<p align="center">Office Action Summary</p>	<p>Application No.</p> <p align="center">10/761,185</p>	<p>Applicant(s)</p> <p align="center">MUTCHLER, AUSTIN W.</p>	
	<p>Examiner</p> <p align="center">Jerry Cumberledge</p>	<p>Art Unit</p> <p align="center">3733</p>

DETAILED ACTION

FIG. 1

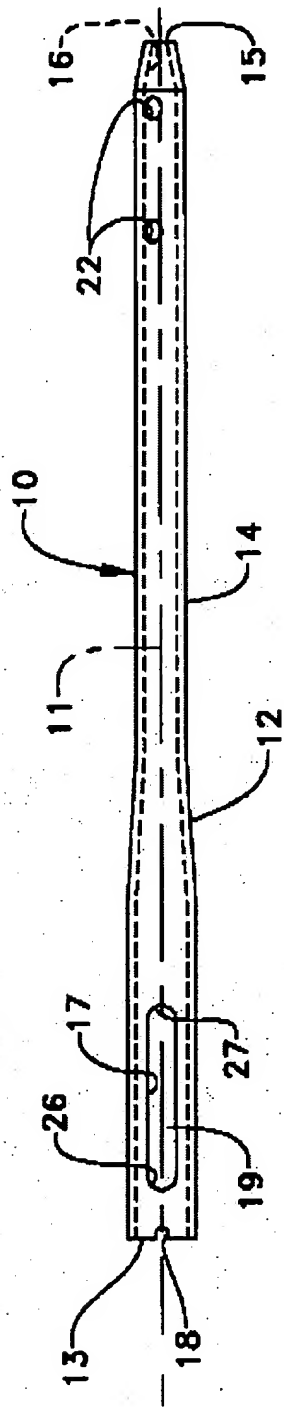
Border discloses an intramedullary nail for use with a first fastener and a second fastener for use in orthopedic surgery, said nail comprising a body (Fig. 1, 10) defining a longitudinal axis thereof, the body defining an aperture (Fig 1, 16) therethrough, the aperture having a first portion (Fig 1, 17) capable of cooperation with a first fastener to provide dynamic fixation and having a second portion (Fig 1, 22) capable of cooperation with a second fastener to provide static fixation. The definition of axis, according to the Merriam-Webster Online Dictionary, is "a straight line about which a body or a geometric figure rotates or may be supposed to rotate." Since the nail can rotate in any direction around any line or point where the nail exists in space, the axes can be anywhere in the body of the nail, in any orientation. This definition of axis will be applied throughout this office action. The "portions" can be considered part of the slot since they are continuous with the slot.

The slot (Fig 1, 16) has a rectangular central section. As seen in Fig 1, the cross section of the middle of the slot has a rectangular section. It also has a cylindrical end section (Fig. 1, 26) adjoining the rectangular central section. The cylindrical end section is capable of matingly fitting with the first fastener. The cylindrical end section is capable of slidable fit and threadable fit with the first fastener. The definition of thread, according to the Merriam-Webster Online Dictionary, is "to pass something through in the manner of a thread". The end is capable of threadable fit with the first fastener, since the screw could be placed through the end section. The aperture is capable of

Border further discloses an intramedullary nail for use in orthopaedic surgery, said nail comprising: a body (Fig. 1, 10) defining a longitudinal axis and a transverse axis thereof, the transverse axis being normal the longitudinal axis, the body defining an aperture (Fig 1, 16) therethrough, the aperture being substantially longer in the longitudinal axis than in transverse axis. The aperture is longer in some directions than others, and, applying the definition of axis, the axis can exist anywhere the nail is and in

any direction. The aperture defines an enlarged portion (Fig 1, 17) thereof along the longitudinal axis. Enlarge is defined by the Merriam-Webster Online Dictionary as "extend." It is longer in one direction than the other (Fig. 1, 17), hence it is extended in one direction and enlarged. The aperture has a rectangular central section. As seen in Fig 1, the cross section of the middle of the slot has a rectangular section. The enlarged portion forms a generally cylindrical section and is positioned adjacent an end of the aperture. Viewing the enlarged portions from above the nail, as in Fig. 1 and Fig. 5, they have a generally cylindrical shape. Border discloses a fastener (Fig 3, 34) capable of cooperation with the body. The cylindrical section of said body is capable of matingly fitting with said fastener. The cylindrical section is capable of slidable and threadable fit with said fastener. The aperture is capable of a slidable fit with the fastener with said body, along the longitudinal axis of said body. The aperture further includes a second enlarged cylindrical section (Fig. 1, 22) opposed to the first mentioned cylindrical section. Border discloses a resorbable component capable of cooperation with said body adjacent the aperture (Fig. 1,19). The resorbable component comprises external threads formed thereon (column 4, lines 31-35). The enlarged portion is adjacent an end of the aperture. According to the Merriam-Webster Online Dictionary, the definition of adjacent is "not distant". The enlarged portion is only a few inches from the end of the aperture, which is not distant.

FIG. 3

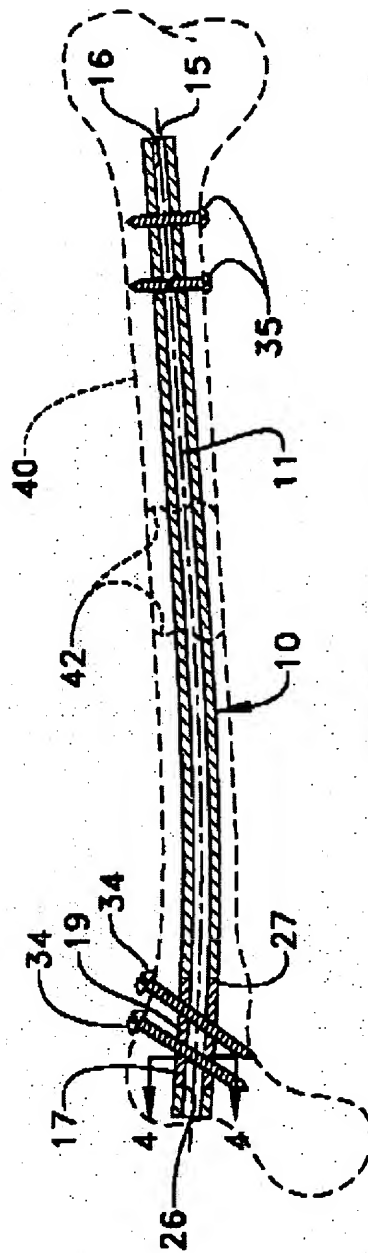
Border further discloses a kit for use in orthopedic surgery, the kit comprising: a first fastener (Fig. 3, 34); a second fastener (Fig. 3, 34); and an intramedullary nail comprising a body (Fig. 1, 10) defining a longitudinal axis thereof, body defining an aperture therethrough (Fig 1, 16), the aperture having first portion (Fig 1, 17) capable of cooperation with said first fastener to provide dynamic fixation and having second portion capable of cooperation with said second fastener to provide static fixation (Fig 1, 22). The slot has a rectangular central section. As seen in Fig 1, the cross section of the middle of the slot has a rectangular section. It also has a cylindrical end section (Fig. 1, 26), which is attached to the rectangular section. The cylindrical end section is capable of matingly fitting with the first fastener. The cylindrical end section is capable of slidable fit and threadable fit with the first fastener. The aperture is capable of providing for a slidable fit of the first fastener with said body along the longitudinal axis of said body. The slot further includes a second cylindrical end section (Fig. 1, 22)

Fig. 9

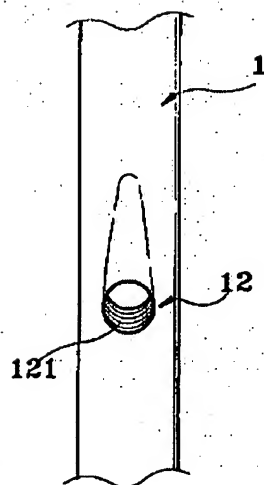
Emilio et al. disclose the body adjacent the first mentioned cylindrical end (Fig. 12 below, 130) defining internal threads therein (Fig. 12, 131) and the body adjacent the second cylindrical end (Fig. 12, 140) defining internal threads therein (Fig. 12, 141) (see also Fig. 9 below), for engagement and guiding of screws (Column 5, lines 19-24).

Fig. 12

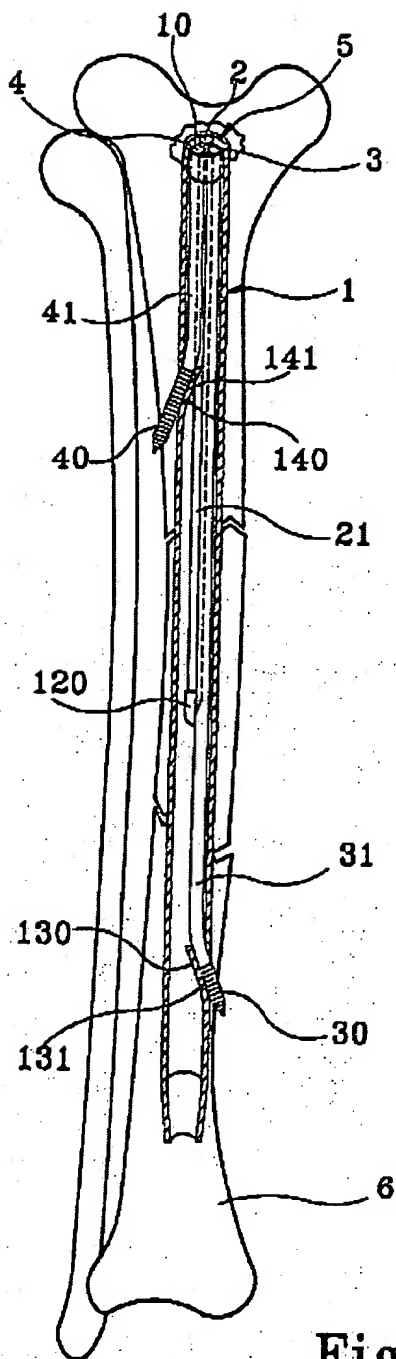
It would have been obvious to a person having ordinary skill in the art at the time the invention was made to construct the body adjacent the aperture of Border with the internal threads of Emilio et al., in order for the internal threads to engage and guide screws used to fasten the nail to the bone (Column 5, lines 19-24).
